HISTORIC AND DESIGN REVIEW COMMISSION

HDRC CASE NO: 2021-085
ADDRESS: 4002 ROOSEVELT AVE
LEGAL DESCRIPTION: NCB 7464 BLK 2 LOT 1 HARLANDALE MEMORIAL STADIUM
SUBD.
ZONING: I-1, H
CITY COUNCIL DIST.: 3
PUBLIC PROPERTY: Yes
DISTRICT: Mission Historic District
APPLICANT: Suresh Modadugu/RVK ARCHITECTS
OWNER: Kyle Blakeney/HARLANDALE I S D
TYPE OF WORK: Site and utility work, surface parking, soccer field construction
APPLICATION RECEIVED: February 11, 2021
60-DAY REVIEW: Not applicable due to City Council Emergency Orders
CASE MANAGER: Edward Hall

The applicant is requesting a Certificate of Appropriateness for approval to perform site and utility work resulting in the creation of new surface parking, the relocation of soccer fields, landscape improvements, and utility improvements at 4002 Roosevelt, located within the Mission Historic District.

STADIUM BLEACHERS FRAMING PLAN

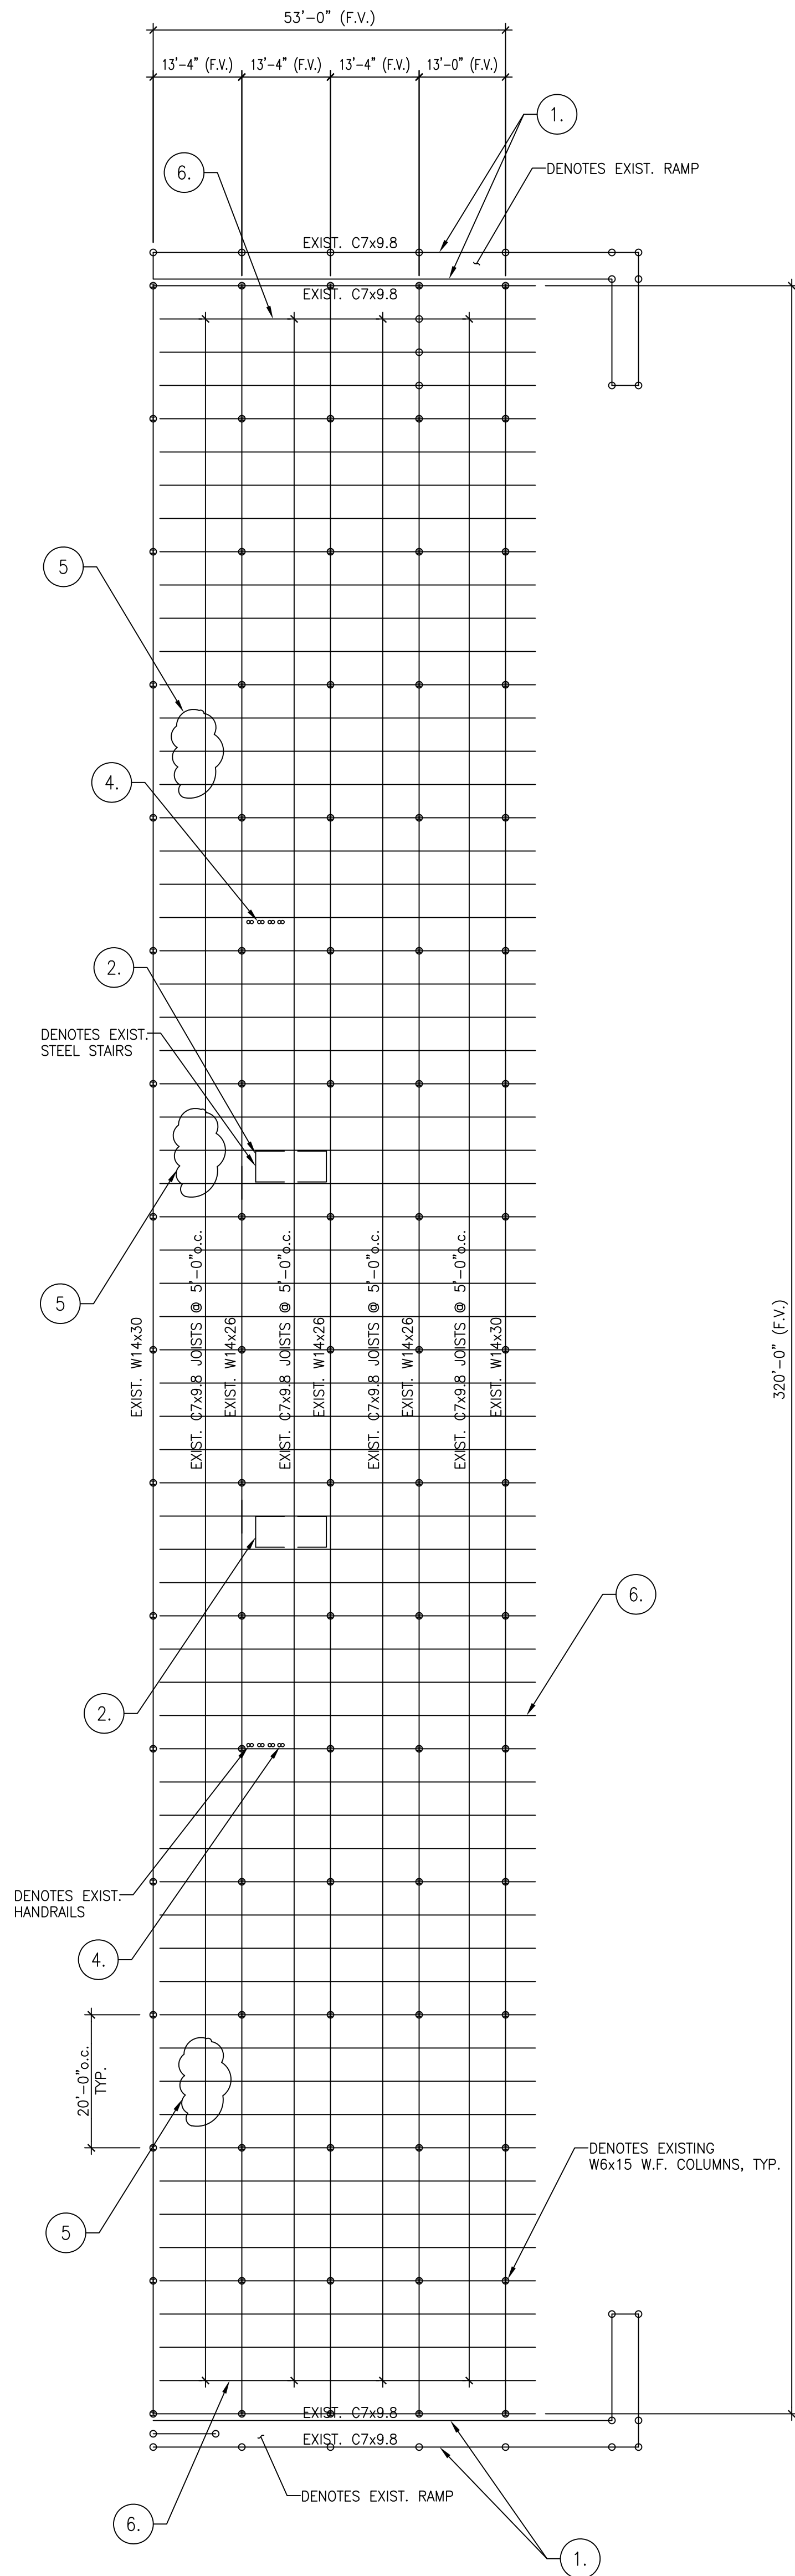
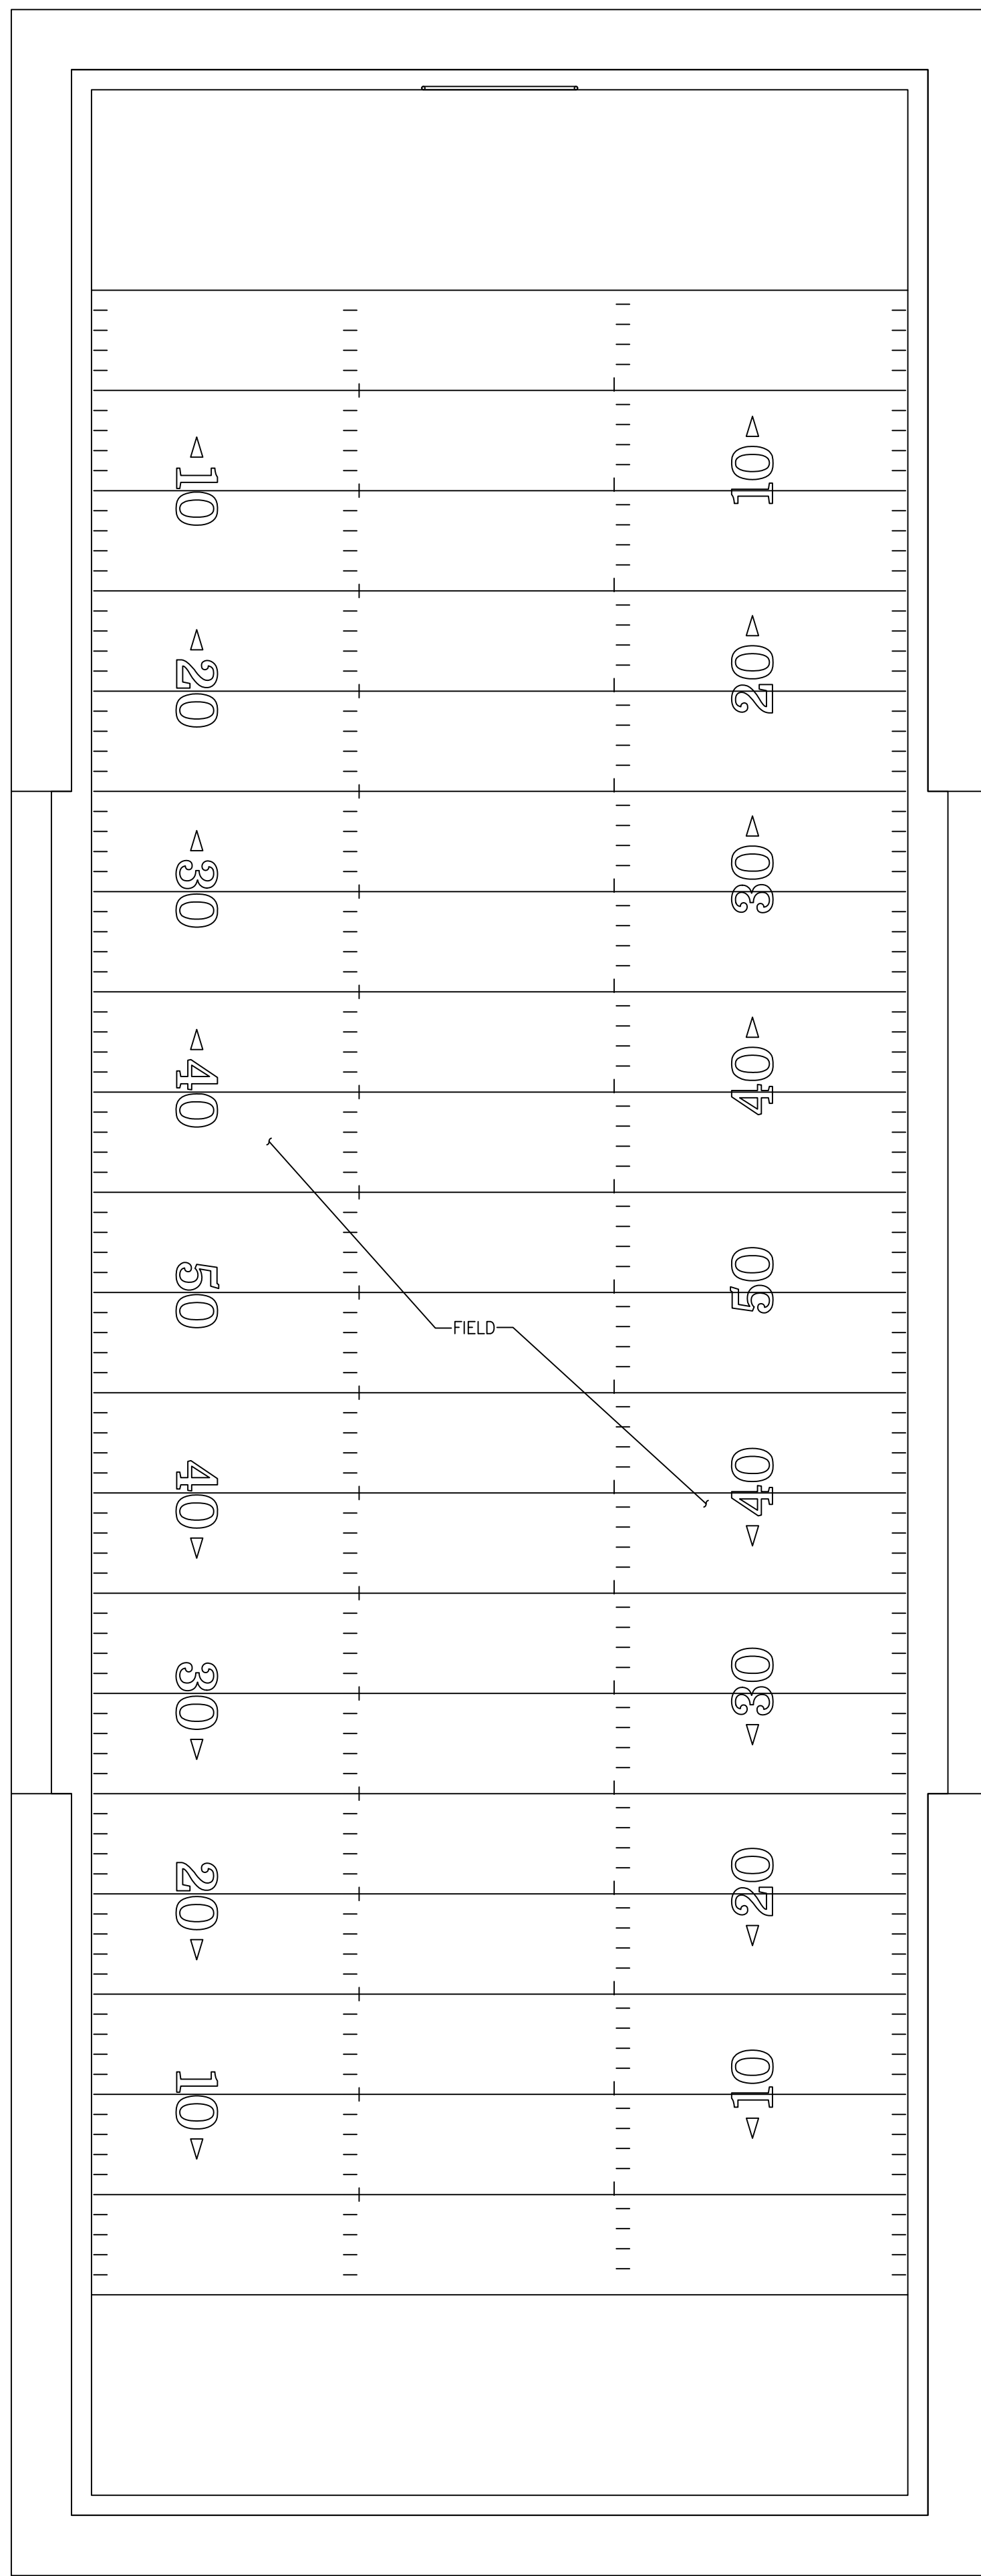
- c. STADIUM BLEACHER REPLACEMENT – The applicant has proposed to replace existing, stadium bleachers. Staff finds this to be appropriate.
- d. ARCHAEOLOGY – The property is located within the Mission Parkway National Register of Historic Places District and Mission Local Historic District. In addition, the project area is in close proximity to previously recorded site 41BX2221. Therefore, an archaeological investigation is required. Construction within public property is subject to the Texas Antiquities Code. The project shall comply with all federal, state, and local laws, rules, and regulations regarding archaeology, as applicable.

ARCHITECTURAL SITE
PLAN - PHASE A

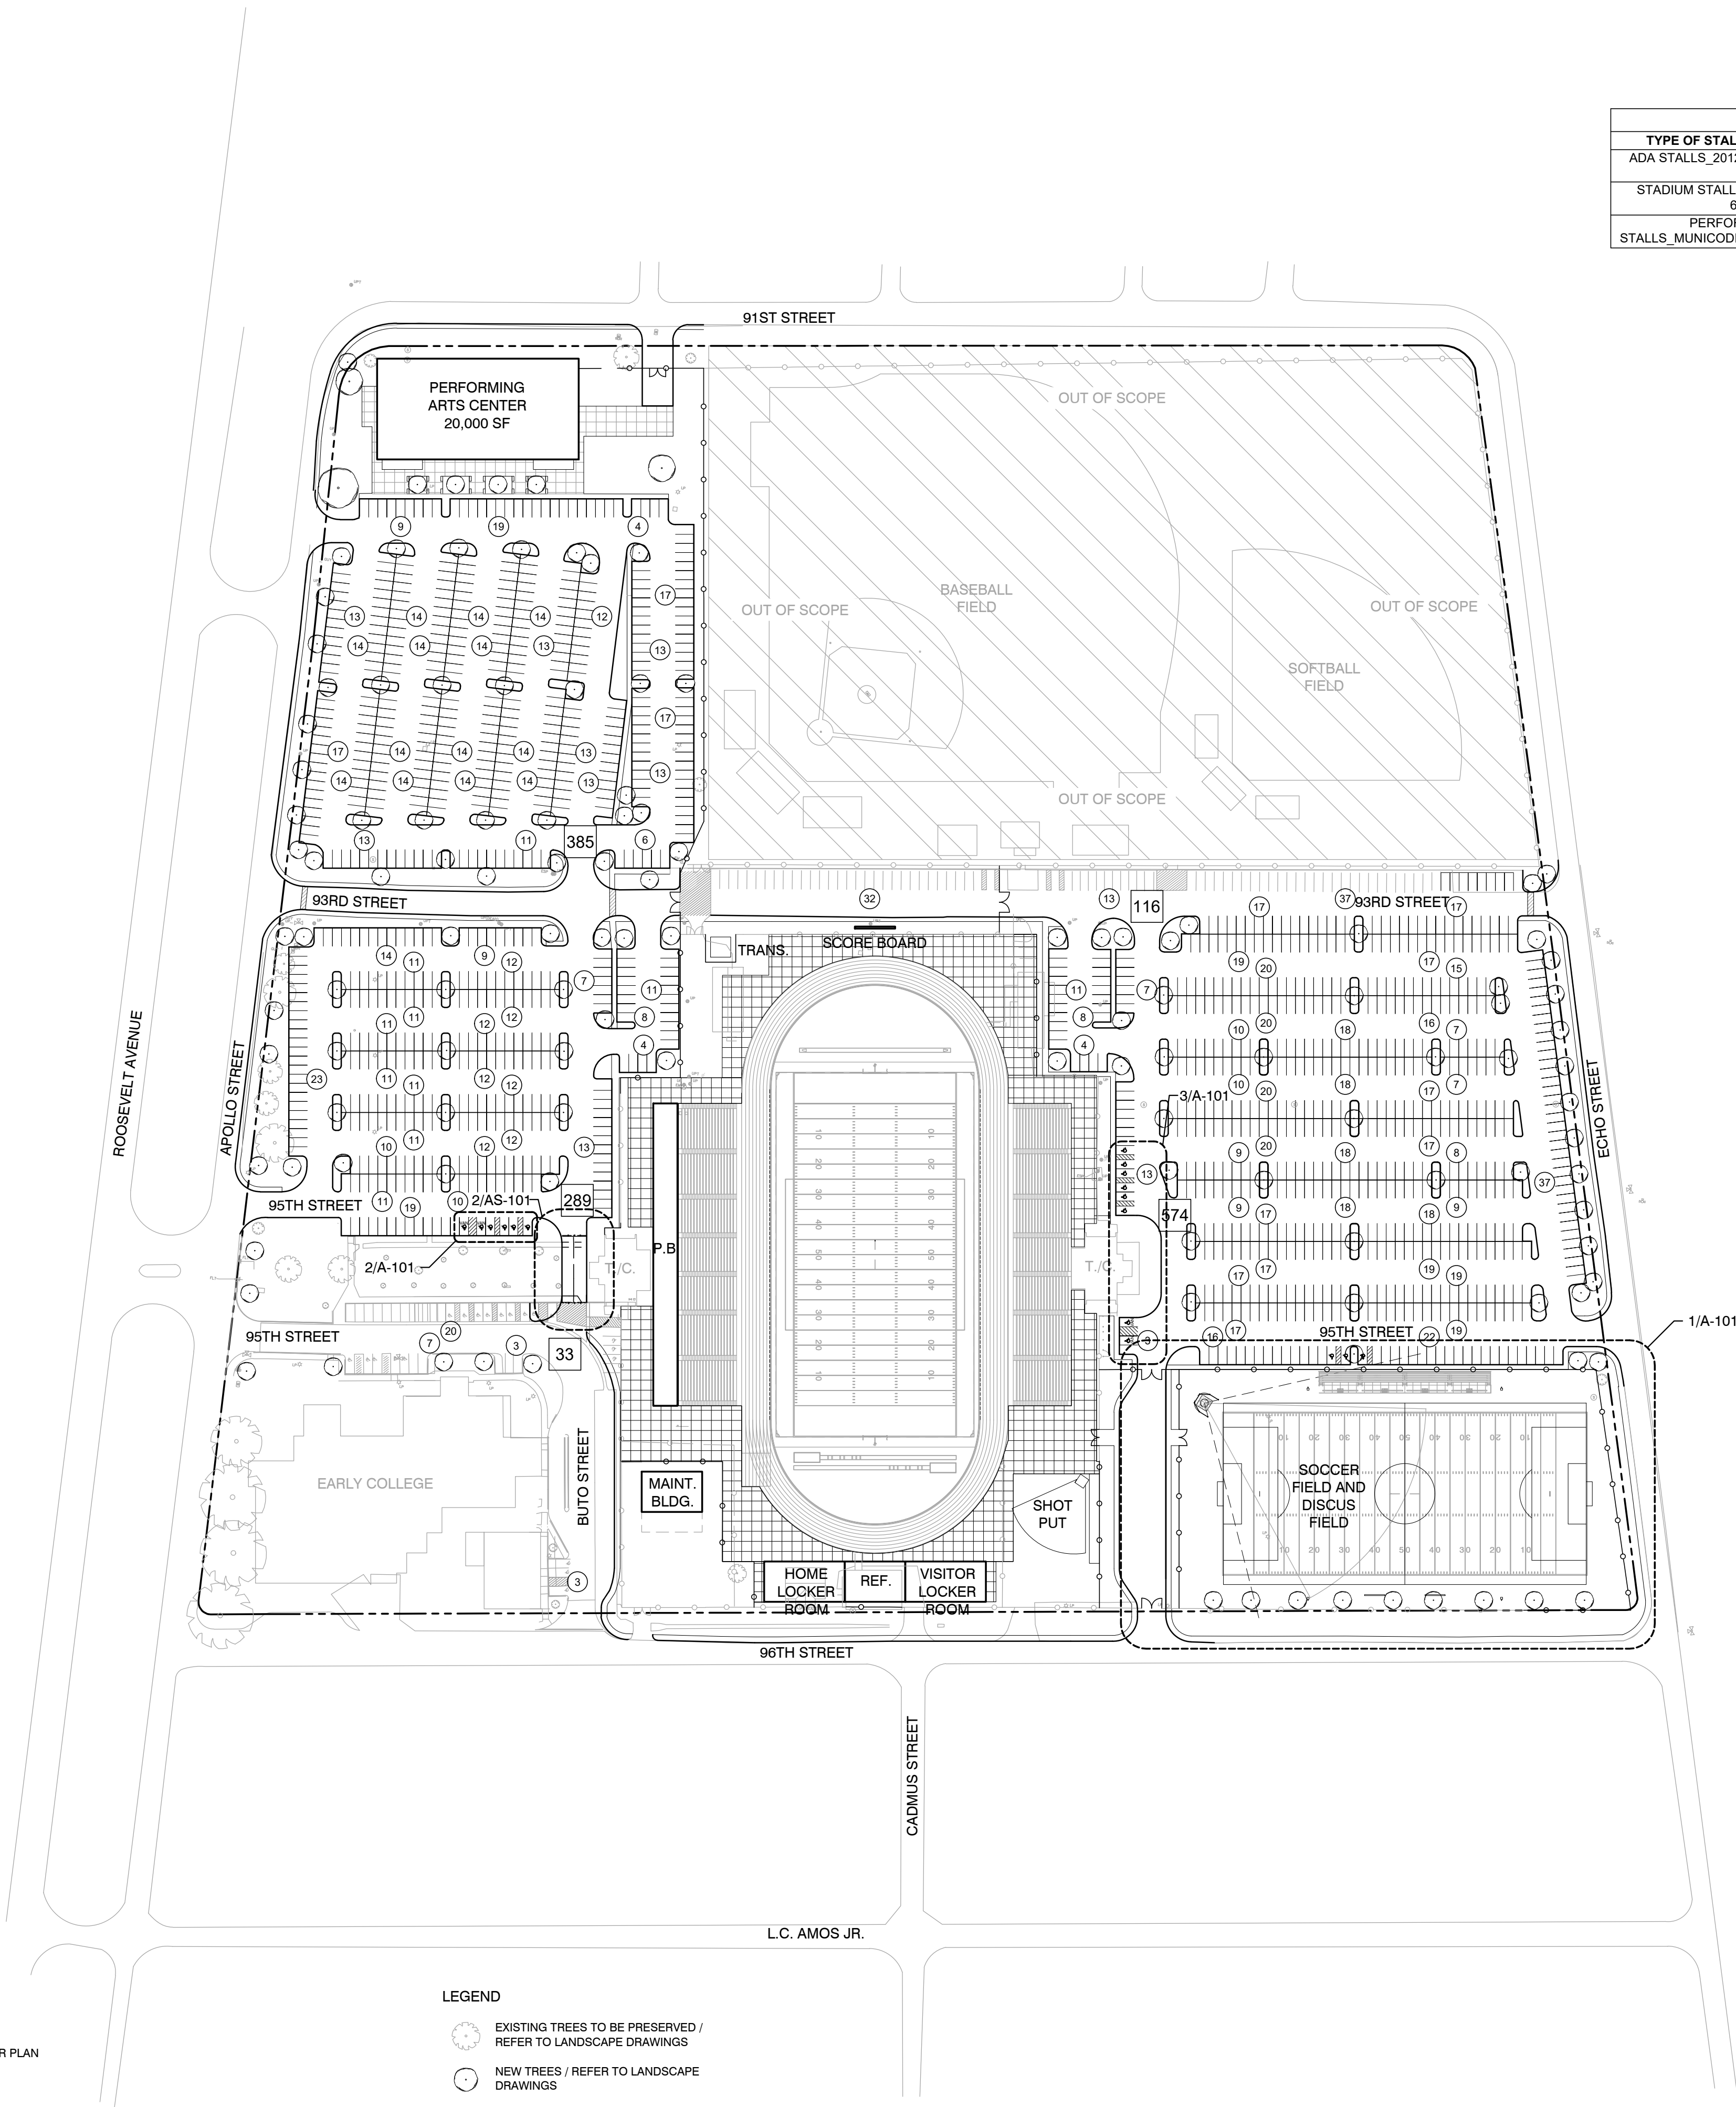
- b. SITE WORK AND PARKING – The applicant has noted the creation of additional surface parking throughout the site. Per the site plan, surface parking appears to be buffered from pedestrian pathways within the site. This is consistent with the Mission Historic District Design Manual. The applicant has noted the installation of site lighting. The applicant should ensure that site lighting does not produce light pollution.
